# RECORD OF PROCEEDINGS CONCORD TOWNSHIP BOARD OF TRUSTEES

July 18, 2024

Mr. Johnson stated the purpose of the meeting was for the Board of Trustees to consider the rezoning application #ZC042024, recommended for conditional approval by the Concord Township Zoning Commission Board, that was filed by DublinbyConcord Ltd, c/o Kiran Basireddy, 6660 N High St, Suite 1E, Worthington, OH 43085. The Applicant is requesting approval for rezoning from Farm Residential (FR-1) to Planned Residential District (PRD), and the preliminary development plan referred to as Hollybrook, at Dublin Road parcels #600-210-02-026-000 at 81.56+/- acres and #600-210-02-031-000 at 27.13+/- acres, Delaware, OH 43015, owned by Virginia & Roy Farneman Co-Trustees.

# HOLLYBROOK

**DEVELOPMENT AS ALLOCATED**

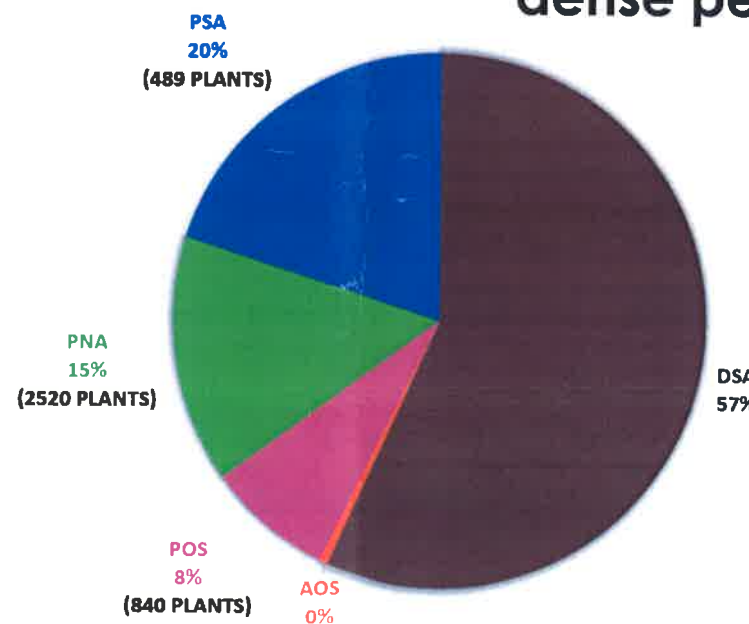
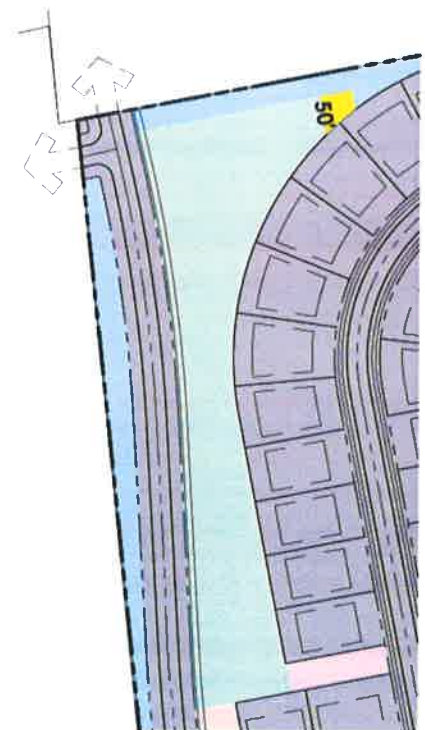
The reviewer notes a reallocation of space is needed to increase the PSA to meet the “better” landscape design standard. This increase in perimeter screening area would not change the required amount of screening material, resulting in a decreased density of the perimeter screening as it is spread over a larger area.

In doing this, the two other areas (POS and PNA) would be reduced, requiring more dense planting interior to the site and eliminating open active/recreation areas.

The end result is a highly wooded interior and a less dense perimeter buffer with no functional open areas.

DEVELOPMENT SITE DIAGRAM

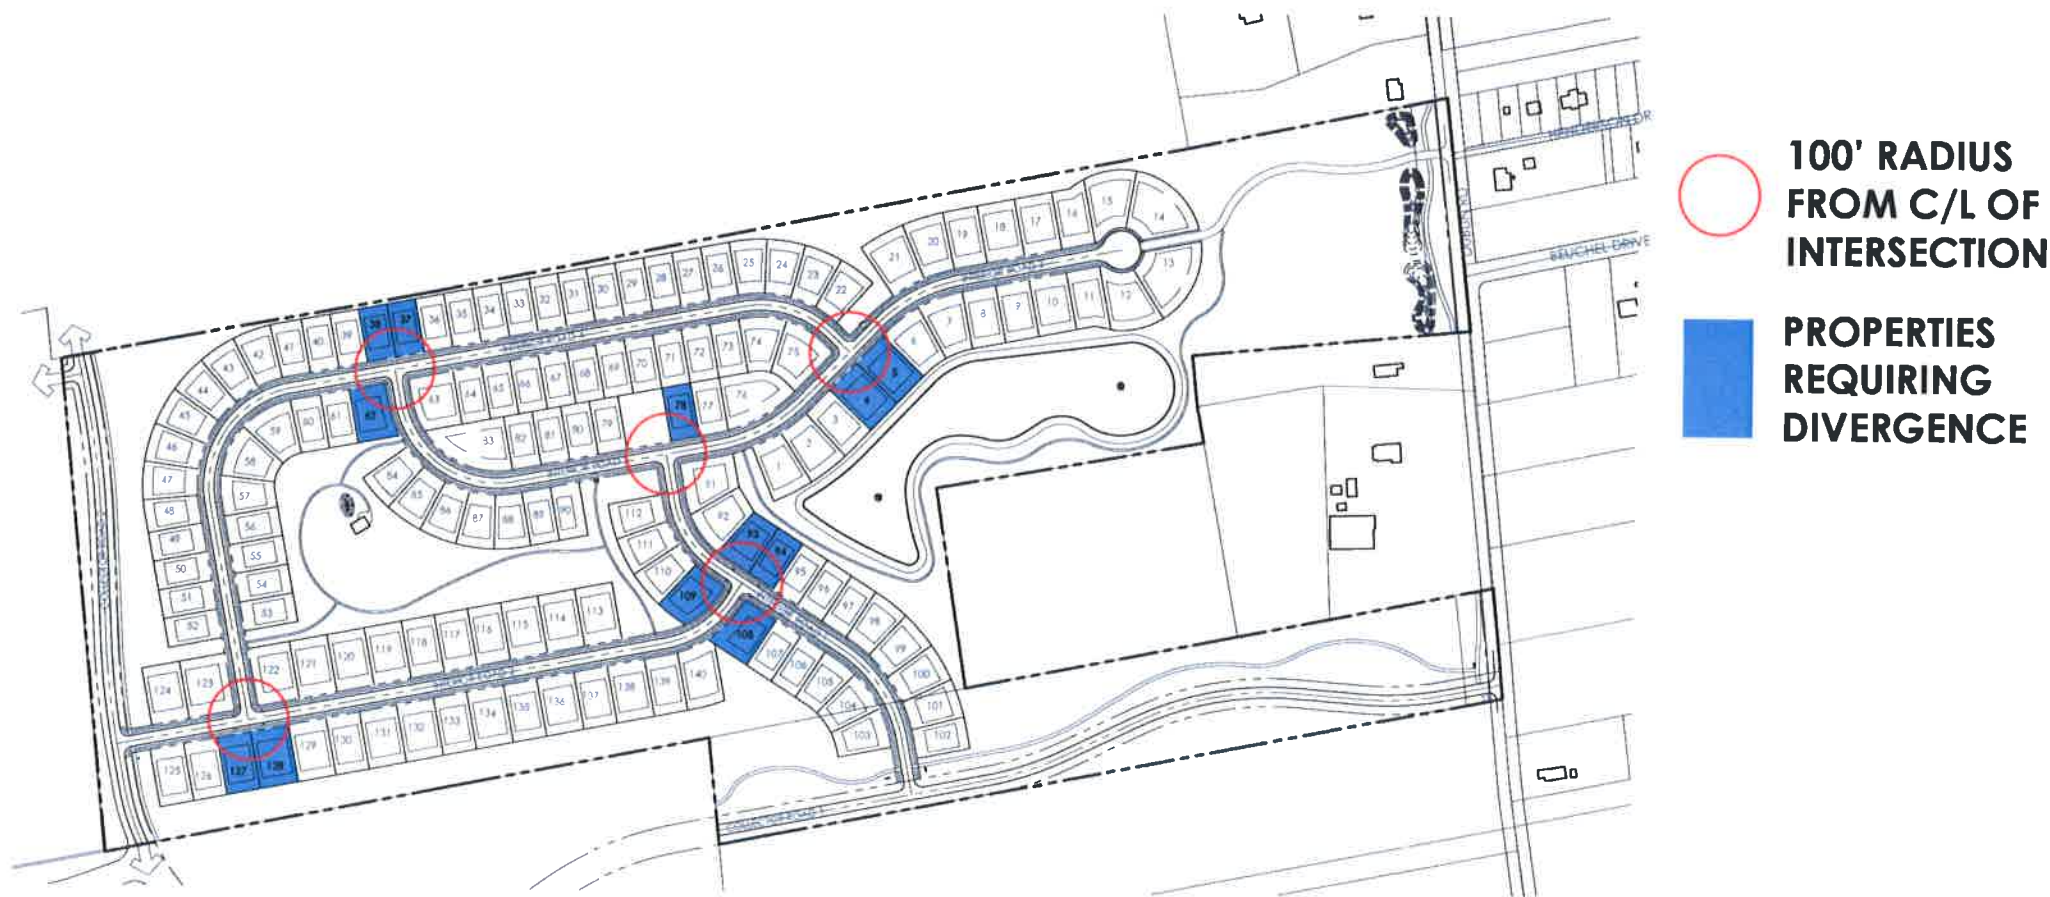
**DELAWARE COUNTY NOTES NEED TO CONFIRM THAT THE PROTECTED NATURAL AREAS MEET THE REQUIRED 50' WIDTH.**

**Small areas of the Protected Natural Areas are narrower than the 50' width required, included to maintain continuity of the spaces.**

**They can be omitted from the PNA and reassigned to another category, or we can ask for a divergence.**

## DIVERGENCE REQUESTED

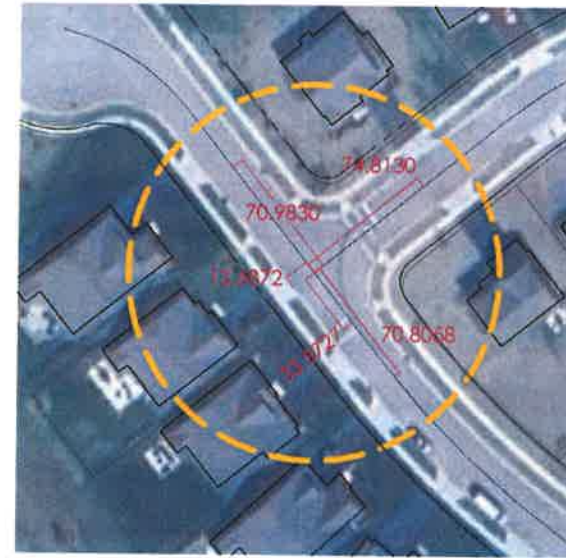
A divergence to Section 21.09 a.12 is requested to allow driveways to be closer than 100' to an intersection of public roads. All corner lots will require this divergence. This divergence has previously been approved for similar subdivisions in Concord Township and is necessary with corner lots and adjacent T intersections within PRD subdivisions as the lot sizes are under 100 feet. Affected lots include lots: 4, 5, 37, 38, 62, 78, 93, 94, 108, 109, 127, and 128. Offsets will range from 35' to 95'.

- **DELAWARE COUNTY HAS NO SPECIFIC REQUIREMENTS FOR DISTANCES OF DRIVEWAYS OFF INTERSECTIONS.**
- **NO CONCERNS NOTED IN INITIAL FIRE DEPARTMENT REVIEW.**
- **DCRPC STAFF FINDS DIVERGENCE REQUEST REASONABLE.**
- **STUDY OF MULTIPLE CONCORD TOWNSHIP NEIGHBORHOODS FINDS MANY EXISTING INTERSECTIONS WITH DRIVEWAYS WITHIN THE 100' RADIUS**
